PLANNING BOARD MEETING AGENDA

July 29, 2026 at 7:30 PM

To: Village of Wesley Hills Planning Board

Re: Friedman – 12A Martha Road Special Permit and Site Plan
SBL# 41.14-1-62; R-50 Zoning District

Rachel B. Barese, P.E.
N.Y. Lic. No. 90143

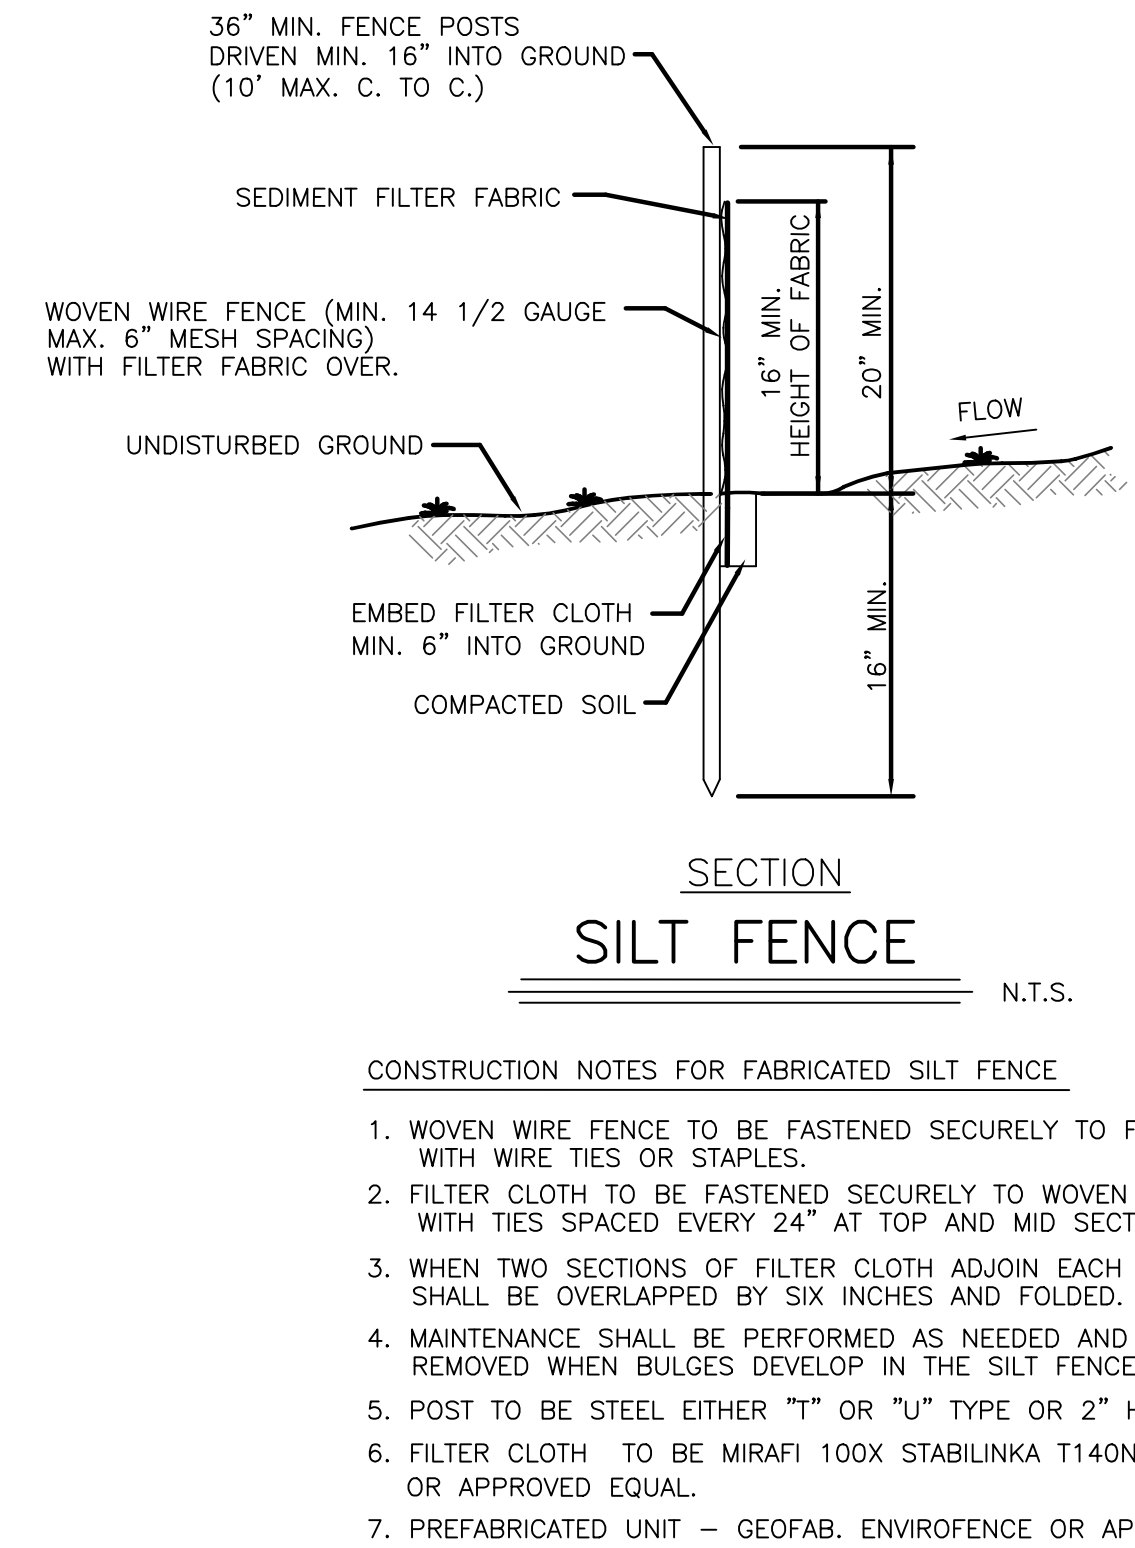
1. Portion of existing pavement is proposed to be removed, soil restoration detail remains to be provided.
2. It is not clear what feature/material is proposed on the west side of the roundabout. Proposed materials remain to be clarified, and labels remain to be provided.

3. It appears as "Pervious Stepping Stones" are no longer proposed near entrance to the house. This remains to be clarified and revised accordingly.
4. For proposed pool please show 4-foot minimum high fencing and self-closing and positive self-latching lockable gate, coping elevation, and spot elevations around the pool to demonstrate stormwater runoff directed away from the pool.

5. Elevations of all corners of proposed house and accessory buildings and structures remain to be provided.
6. Tree protection detail remains to be provided. Please identify trees to be protected on the site plan.

7. Revised drainage calculations show four drywells to be installed for this project. Additional two drywells are now proposed near tennis court; stormwater runoff from the tennis court will be directed into the drainage system.

8. An additional fifth drywell is shown on the west side of the proposed roundabout with no connections. Please clarify what areas will be collected into this drywell. We note that the drainage calculations provided by the Applicant demonstrate that four drywells will satisfy Village requirements for drainage design. Our office has no objections to the installation of the additional drywell on site.

9. Please note, percolation testing will be required for the additional drywells.
10. Per the ZBA condition #2 the Applicant is required to install a berm along the walking path near the tennis court. This berm remains to be shown on the plan.

12. Four ten-foot-high light poles are shown north of the proposed residence. The Applicant shall provide lighting details and demonstrate compliance with §230-54.
